febi 21764

Seat Cordoba,
 Seat Ibiza II, III (1.4 16V AFH, 1.0 16V AVZ)
 VW Polo 3 (1.4 16V AFH)

Repl. No. 036 109 243 J

Timing Belt Tensioner

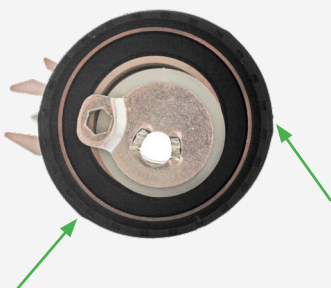
The belt tensioner causes timing belt vibrations which leads to noise.

The original version of the timing belt tensioner (repl. no. 036 109 243 D and 036 109 243 G) is round in shape. The round shape leads to the timing belt vibrations and noise described. This version has been replaced at VW and is no longer in use.

febi recommends using timing belt tensioner febi 21764 (repl. no. 036 109 243 J). This noise-optimised belt tensioner has been developed specially for the applications outlined above. The running surface of the belt tensioner has diagonal elevations (see photos). It is deliberately like this to ensure that the timing belt runs more smoothly. The uneven running surface reduces vibration of the timing belt. At the same time, it also means a longer service life for the timing belt.

The running surface of the tension roller with diagonal elevations is not a production fault! The tightening torque of the tension roller screw is 20 Nm.
